Addendum No. 2
Merrill Virtual Learning Center
Berrien Springs Public Schools

29 December 2020

This addendum forms a part of the Contract Documents and modifies the original Bidding Documents (PROJECT MANUAL dated **07 December 2020**). Please acknowledge receipt of this Addendum when submitting your bid. This Addendum has been distributed to the plan holders of record only. It is the bidder's responsibility to distribute Addendum information to subcontractors and material suppliers. This Addendum reflects modifications from the Owner, Architect, and Bidders.

A1.2

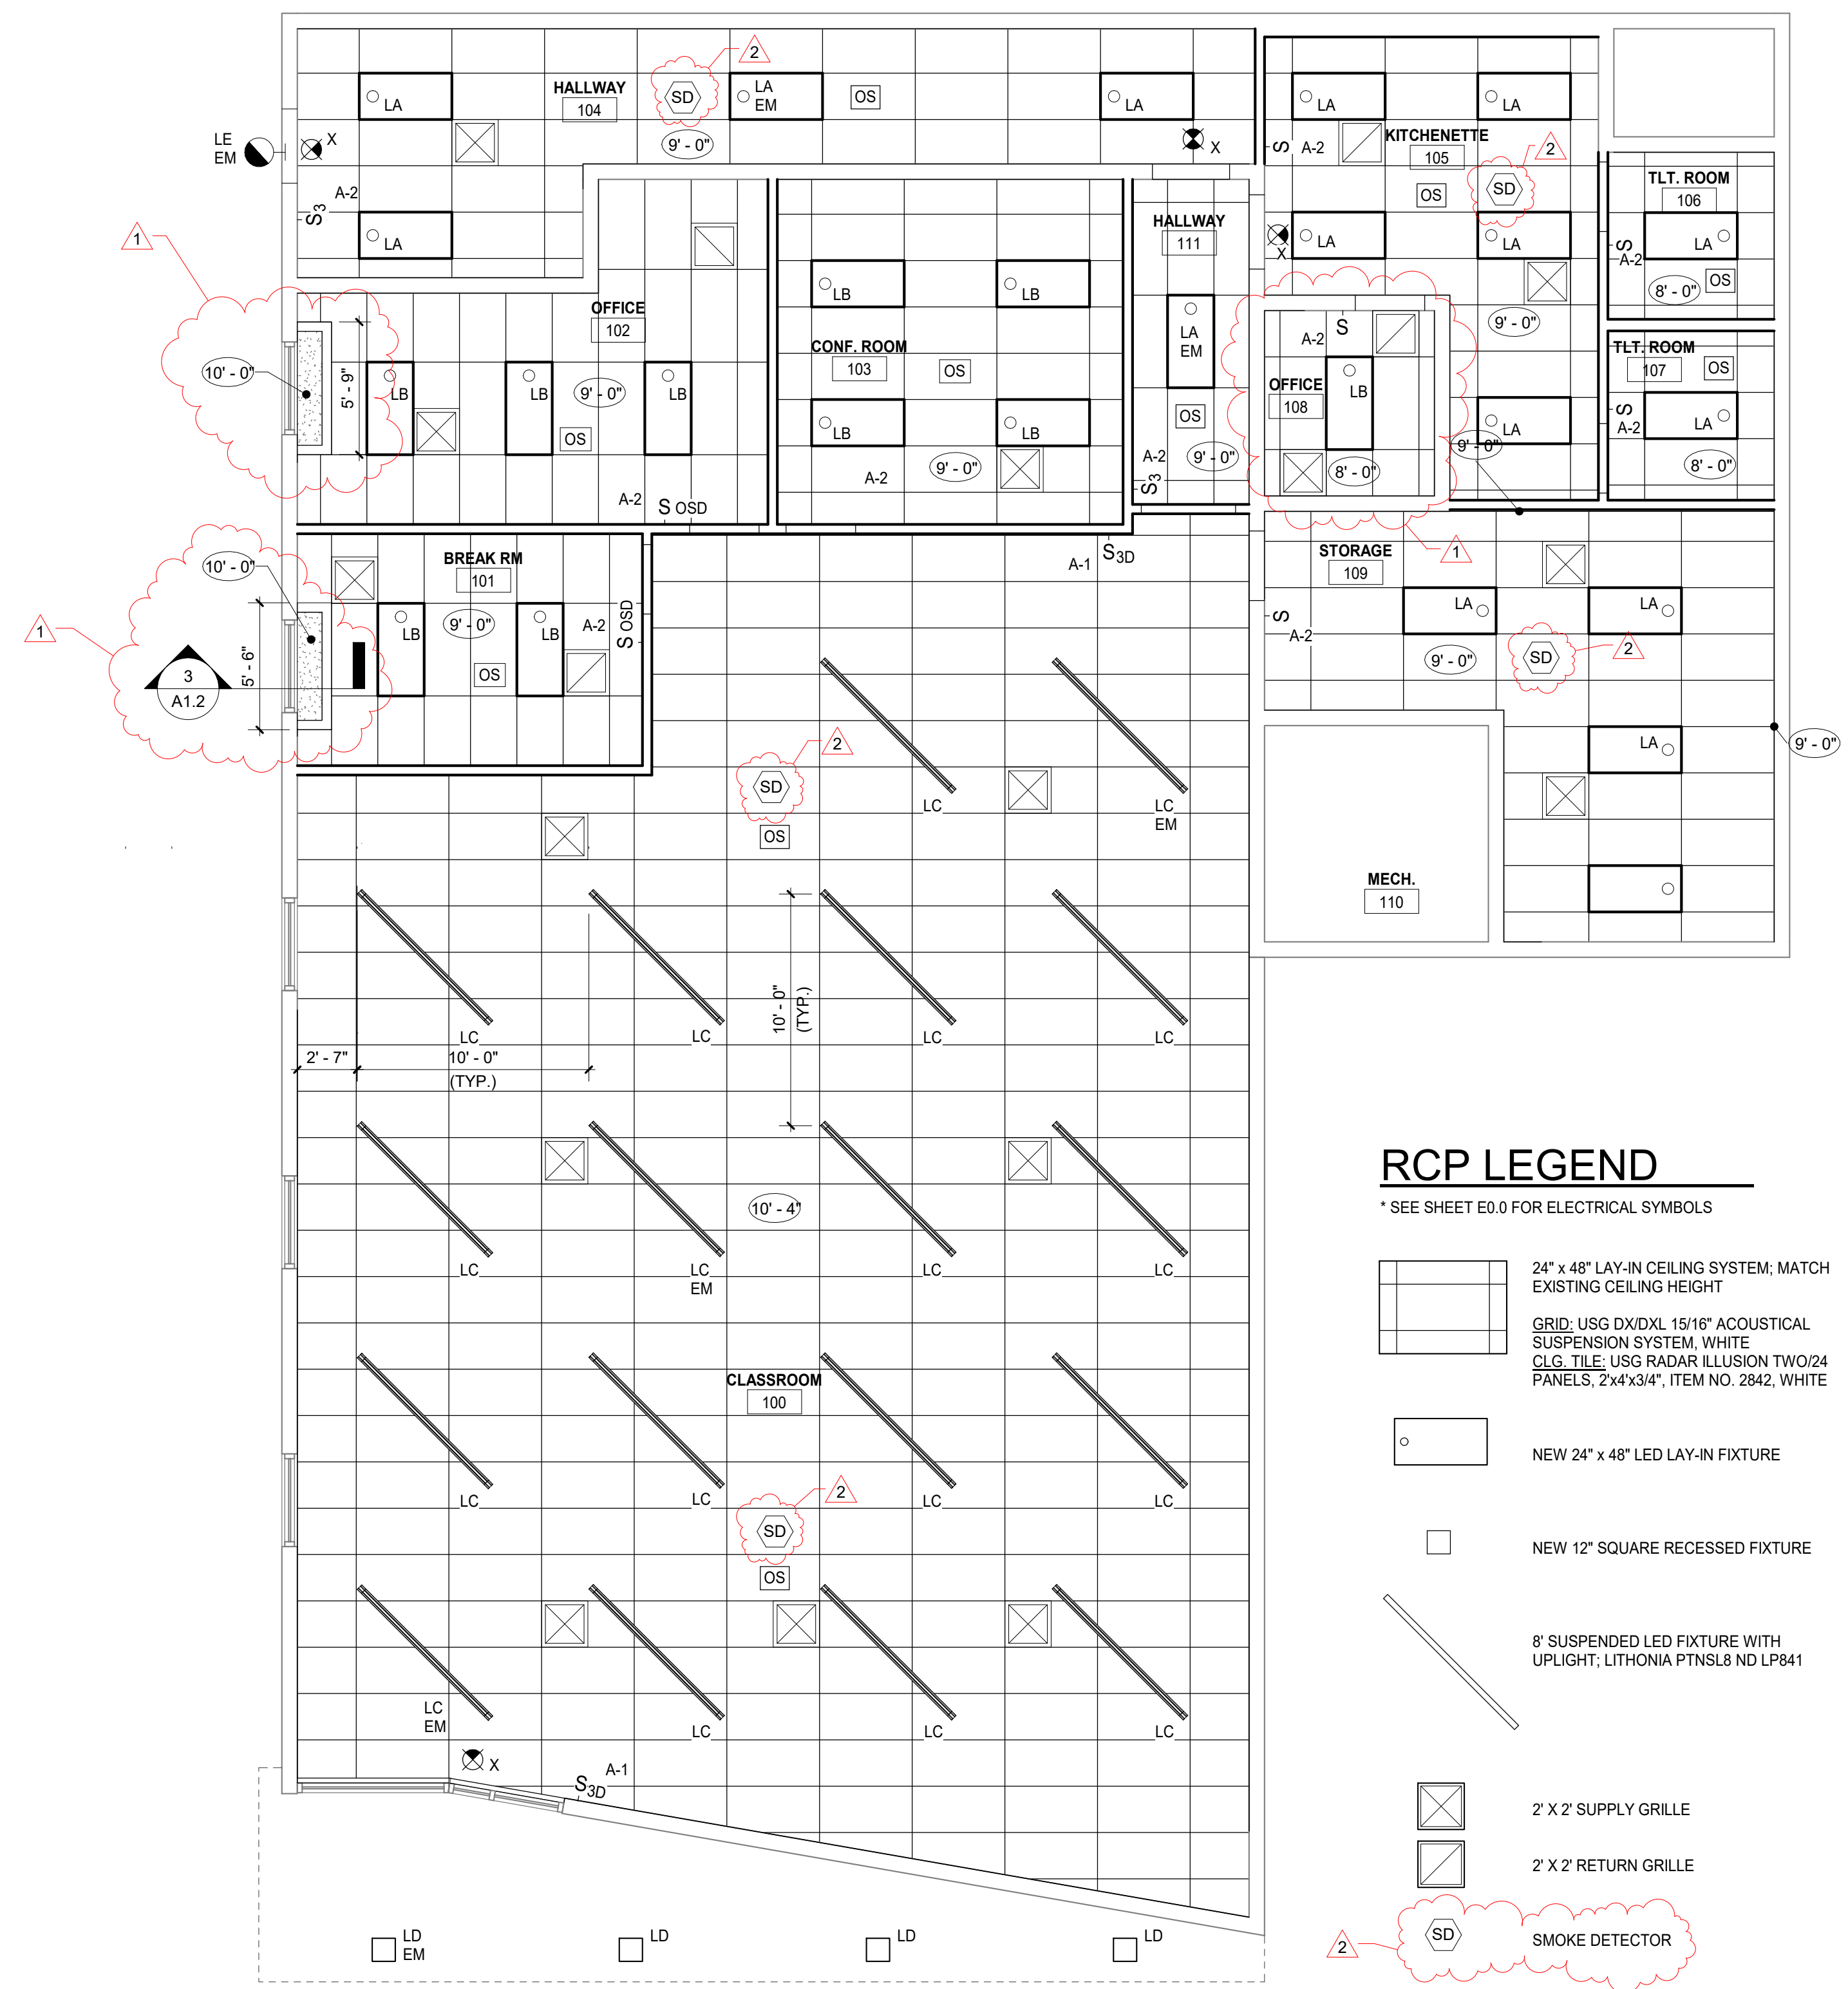
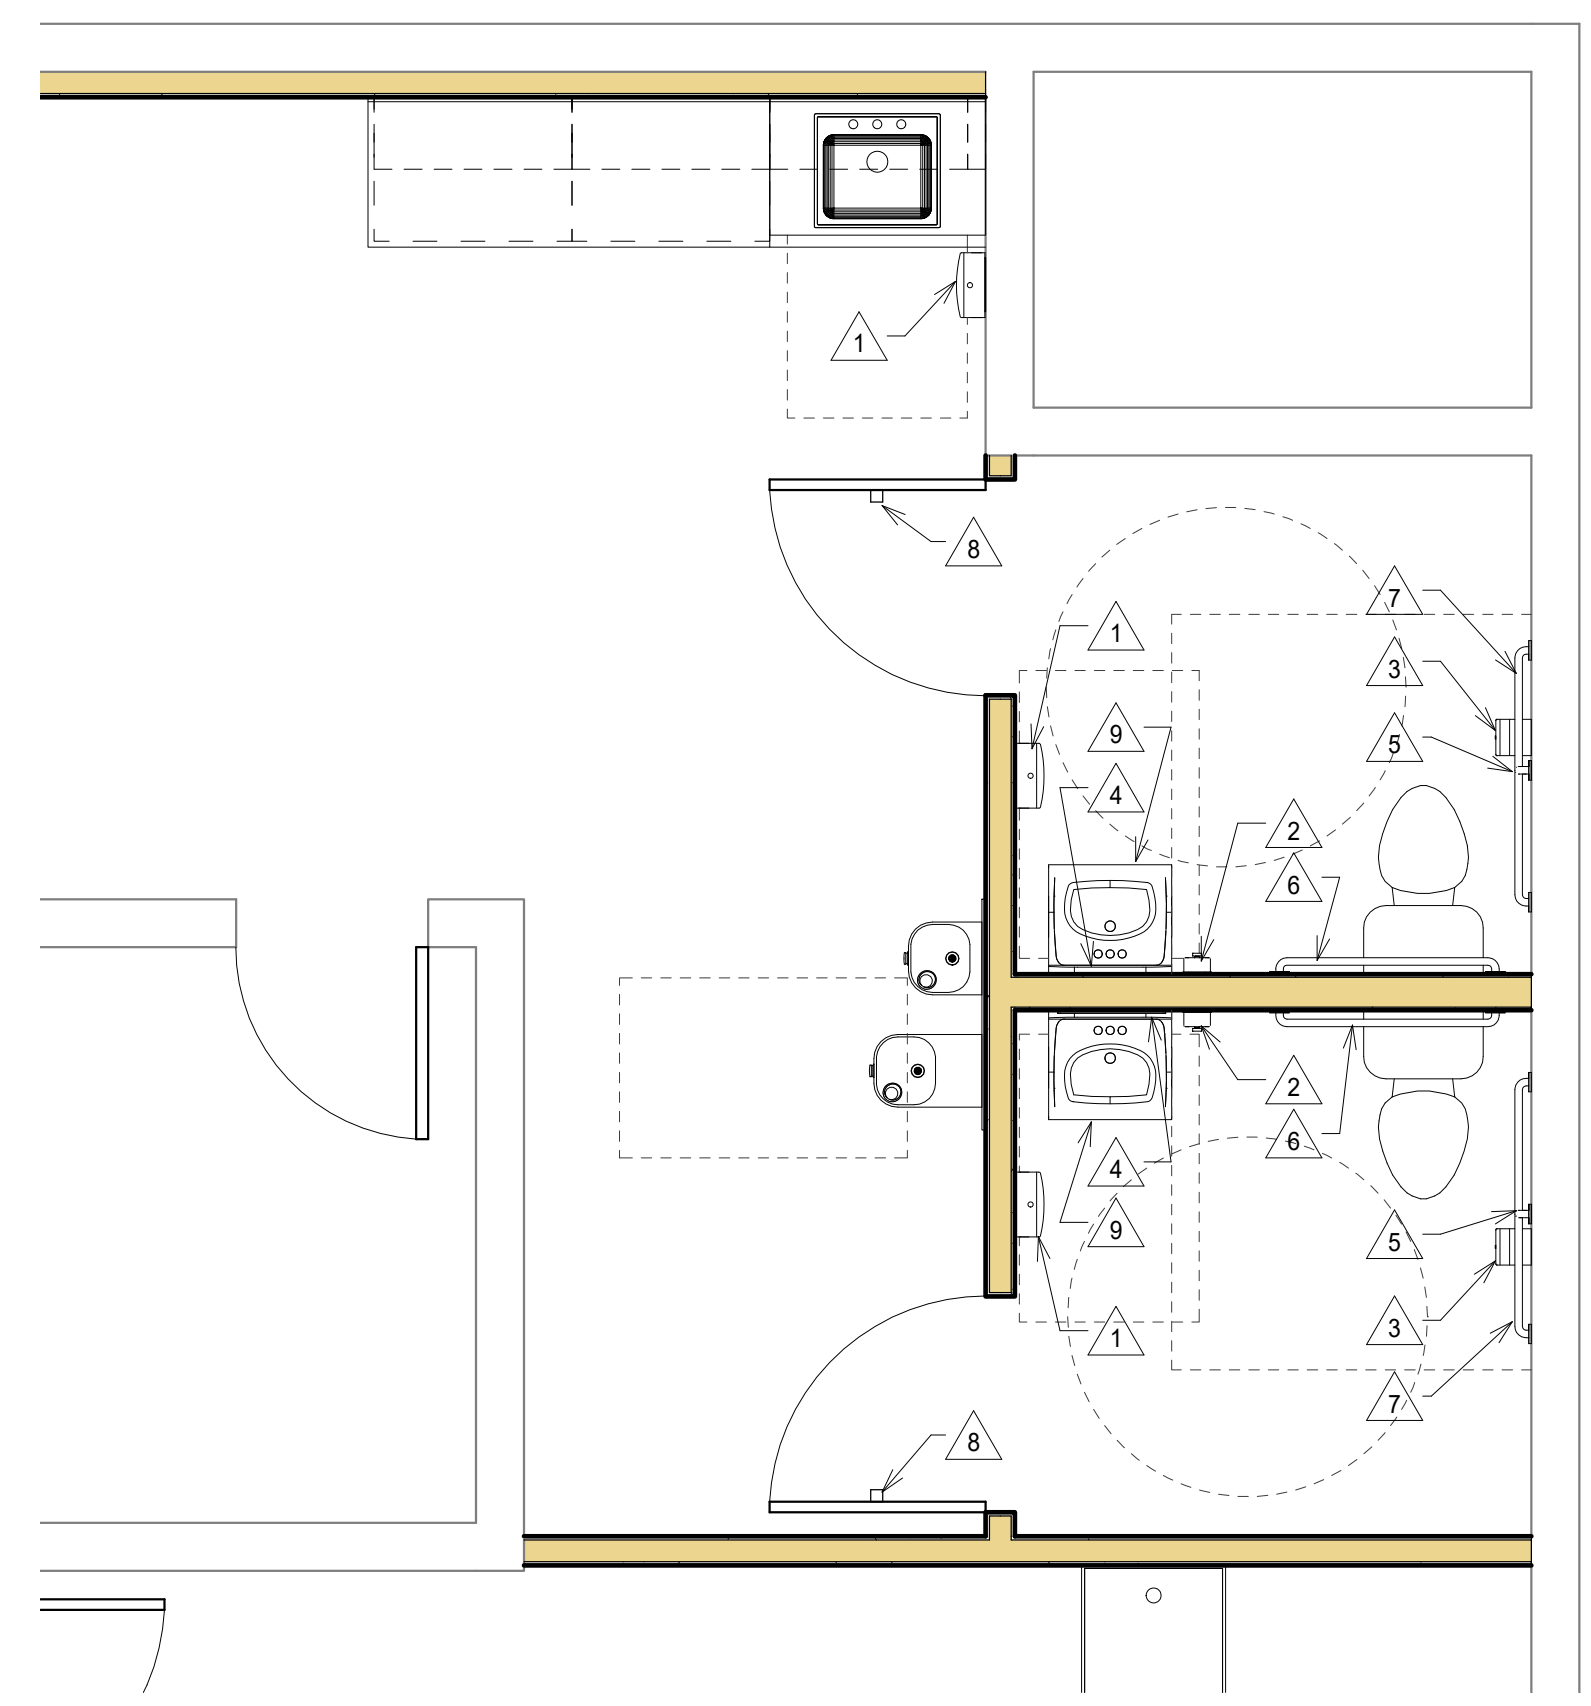
2. Sheet A1.2 Reflected Ceiling Plan and Toilet Room Plans: Install five (5) ceiling mounted smoke detectors in locations shown on plan. Detectors must be hardwired with battery backup and interconnected to produce a building-wide alarm. Mfr.: First Alert or equal. A fire alarm system is not required.
